**DRAFT
ACTION MEMORANDUM**

FOR
**REMEDIAL INVESTIGATION/FEASIBILITY STUDY
SOUTHWEST FUNSTON LANDFILL
FORT RILEY, KANSAS**

Subject: **Draft Action Memorandum**
Southwest Funston Landfill Site/Ft. Riley, Kansas
Contract No. DACW41-89-D-0124
Delivery Order No. 0044
LEGS Project No. 11-2537

FIGURE 3
**RECOMMENDED PROTECTION ALONG
 RIVER BANK**
SOUTHWEST FUNSTON LANDFILL
 FORT RILEY, KANSAS

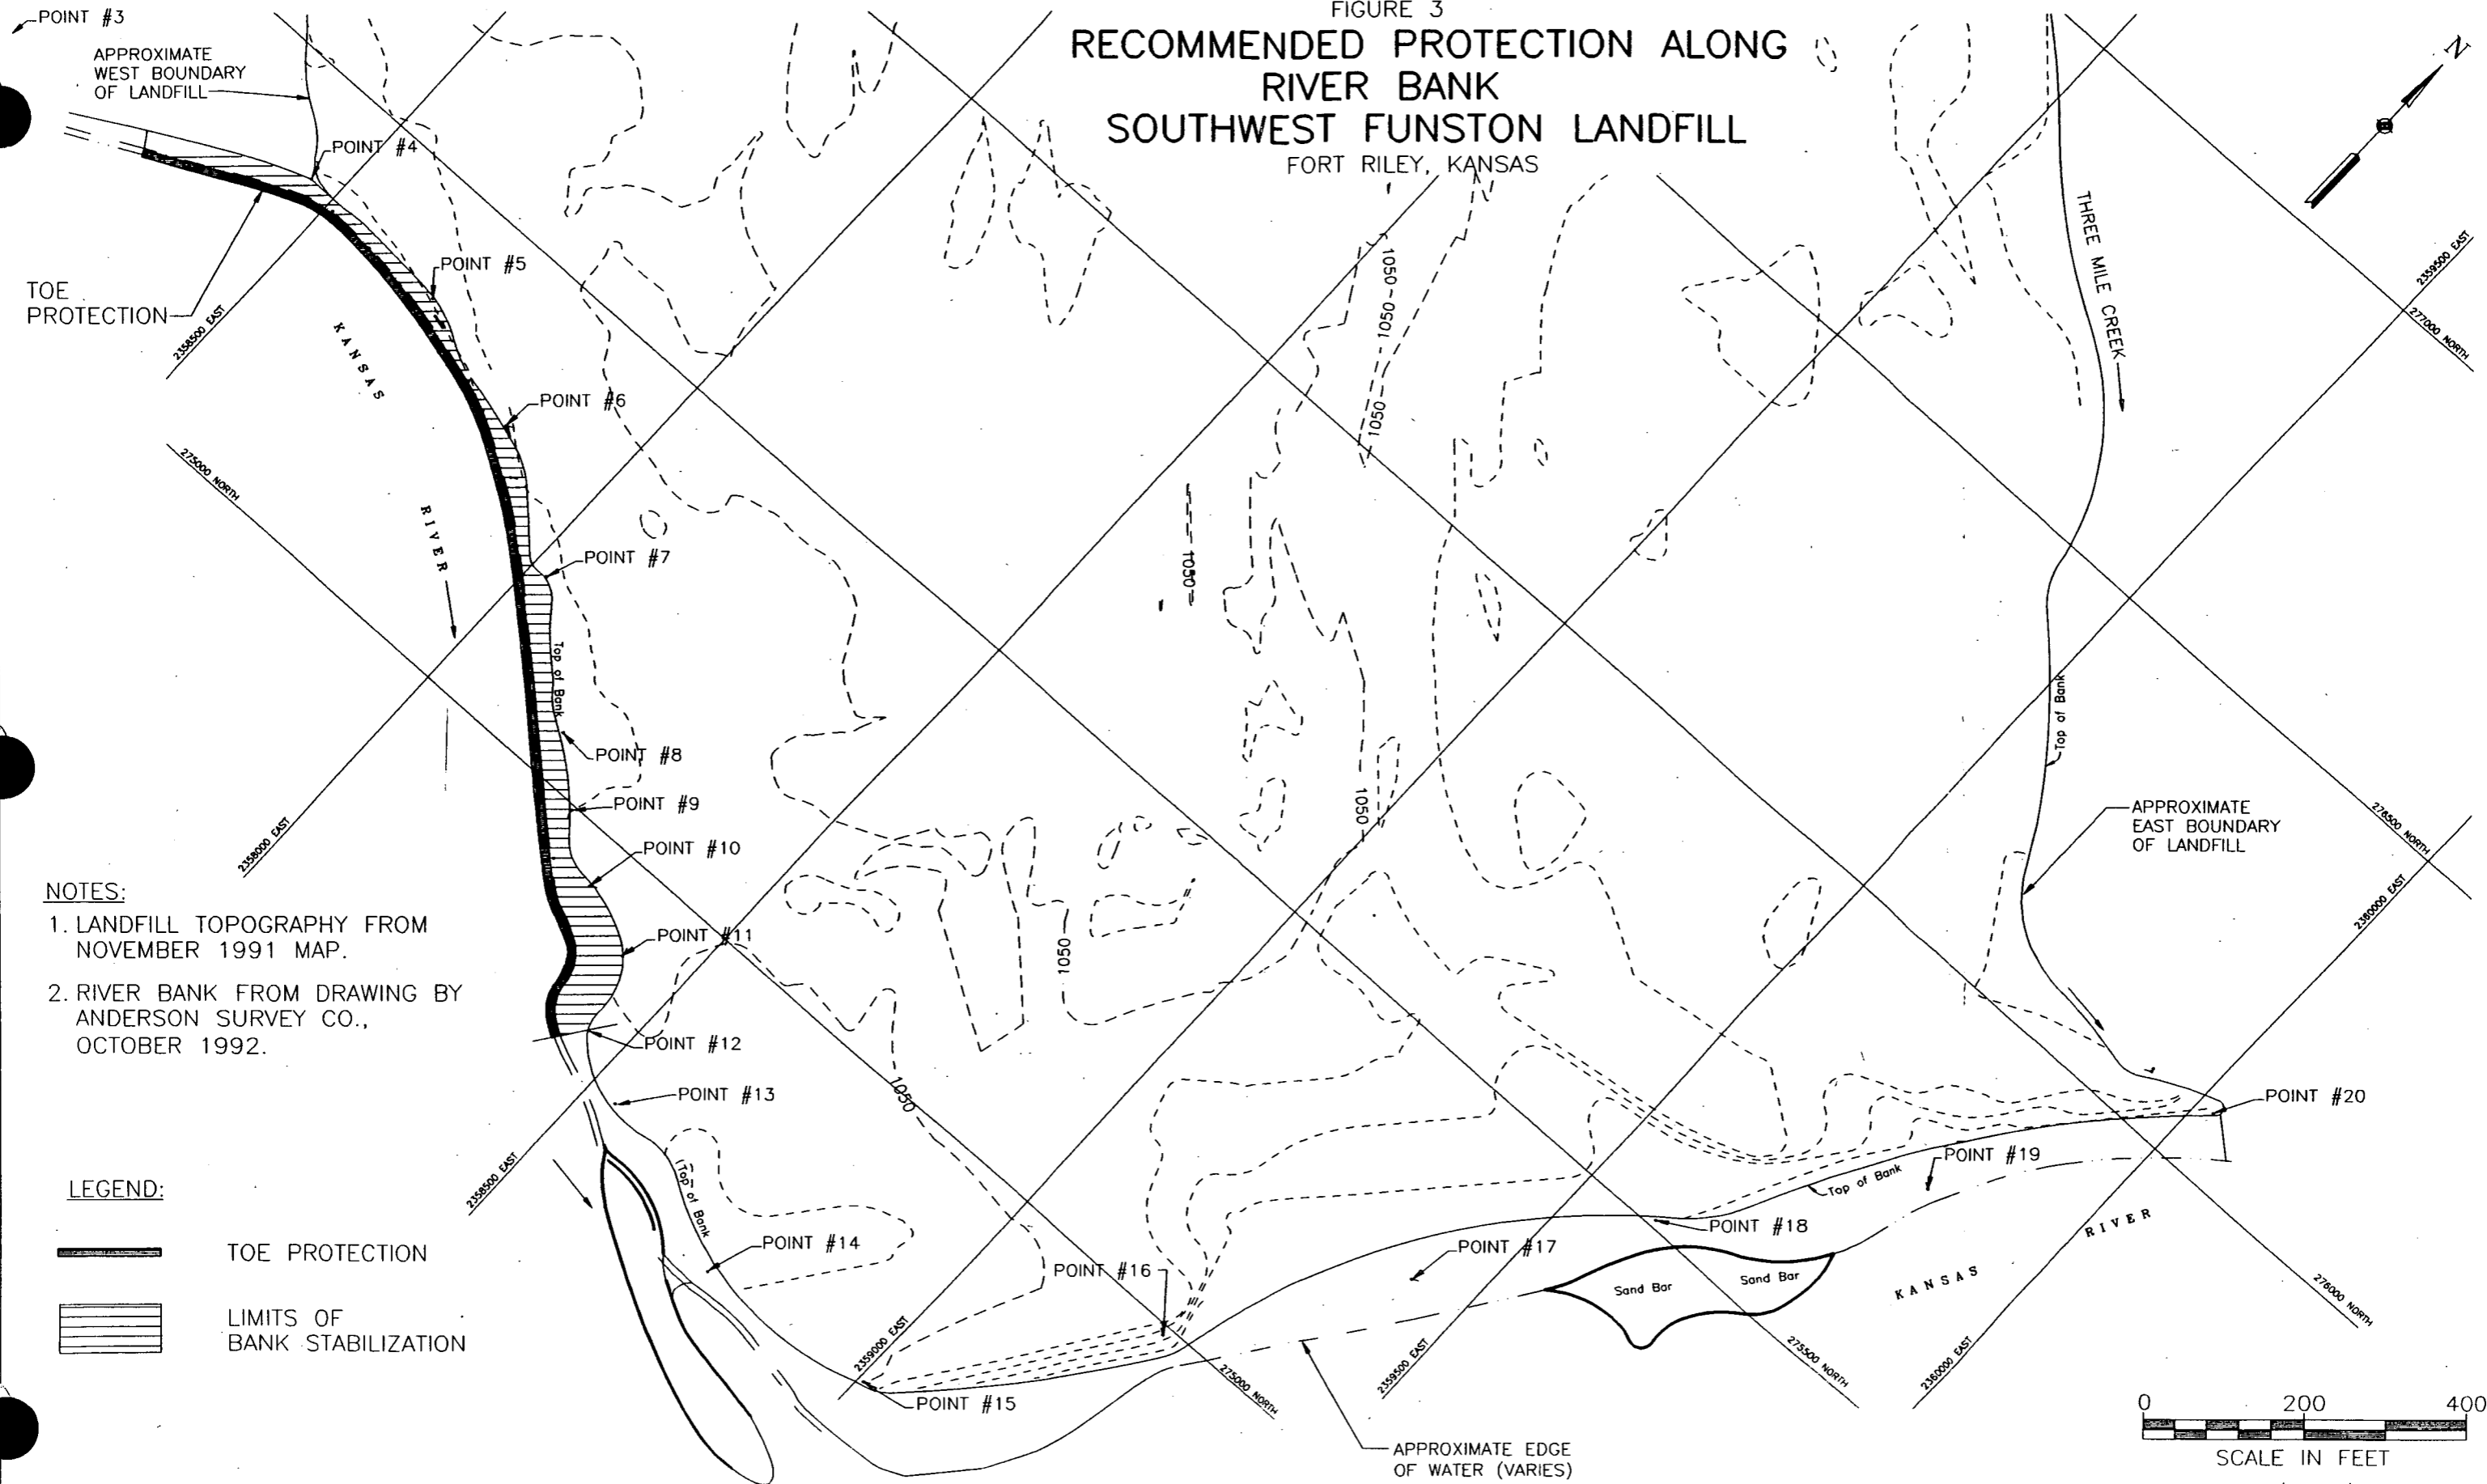
5. EPA suggests that the sheet pile wall alternative be further examined as a viable approach for bank stabilization in the western area of the landfill at areas where high river velocities are anticipated. It is believed that sheet piling may offer improved structural stability compared to the revetment alternative, thereby justifying the increased expense associated with its implementation.

We suggest that you evaluate extending the sheet pile wall from a point west of survey point #4 (see Figure 2-8), due to the erosion which is occurring in this area, to near survey point #7. The revetment option appears viable in the lower velocity areas of the river, downstream of survey point #7. We recommend that the revetment extend past survey point #13, where indications of erosion are present, to approximately survey point #15.

R: Disagree. The sheet pile wall offers no significant structural improvements over the use of rock revetment, is difficult to install (drive) into debris and rubble present along the bank, and is more expensive. The repair and extension of revetment is also accomplished easily, at less cost than a sheet pile wall extension, if needed. The sheet pile wall may increase stream velocities near the bank. Revetment will increase the buffer area between the river and landfill contents by extending the bank slope into the river.
